Access Compliance Report

Public Rights-of-Way

(Curb Ramps)

Intersection ID: 53980	Main Street: ABENDEGO_RD	Cross Street: SUNBURST_LN	Location: S
ADA ID: BEA3BA994585	Ramp Type: BlendTrans1	Initial Pass/Fail: Fail	Overall Compliance: No
Severity Score: 8.75			
Codes/Mitigation Info/Possible Solution		Field Measurements/Component Compliance

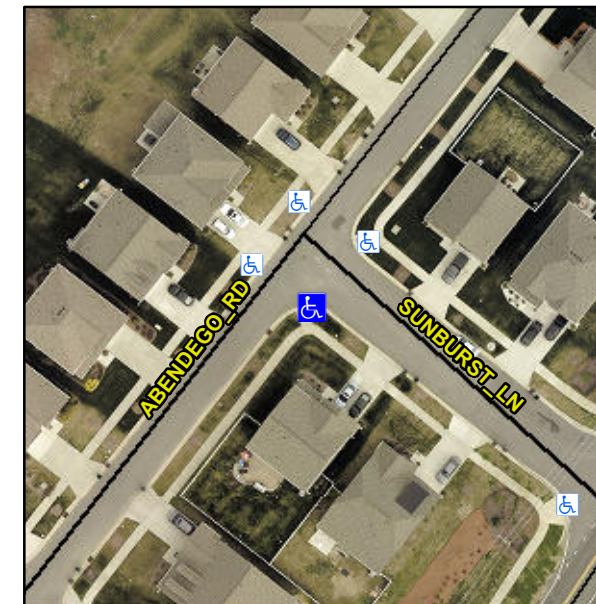
R304.5.1

Compliance	Description	Data	Compliance	Description	Data
N/A	Ramp Length (in)	97.0	Yes	BlendTrans Slope (%)	4.3
No	Ramp Width (in)	47.5	Yes	BlendTrans XSlope (%)	2.0
N/A	Flare Type LT	N/A	N/A	Flare Type RT	N/A
N/A	Flare Slope LT (%)	N/A	N/A	Flare Slope RT (%)	N/A
N/A	Flare Traversable LT?	N/A	N/A	Flare Traversable RT?	N/A
N/A	Landing Length (in)	N/A	N/A	DWS Provided?	N/A
N/A	Landing Width (in)	N/A	N/A	DWS Contrast?	N/A
N/A	Landing Slope (%)	N/A	N/A	DWS Length (in)	N/A
N/A	Landing X Slope (%)	N/A	N/A	DWS Full Width?	N/A
N/A	Landing Curb? (Y/N)	N/A	N/A	DWS Offset (in)	N/A
N/A	Shared Landing?	N/A			
N/A	Gutter Ponding?	N/A	N/A	Gutter Slope (%)	N/A
N/A	Gutter Lip Ht (in)	N/A	N/A	Gutter X Slope (%)	N/A
N/A	Painted X Walk1?	No	N/A	Painted X Walk2?	No
	X Walk 1 Direction	To E		X Walk 2 Direction	To W
	X Walk 1 Width (in)	N/A		X Walk 2 Width (in)	N/A
	X Walk 1 Slope (%)	1.7		X Walk 2 Slope (%)	1.8
	X Walk 1 X Slope (%)	1.8		X Walk 2 X Slope (%)	0.4

Remove & Replace Curb Ramp With Two New Directional Ramps or Equivalent.
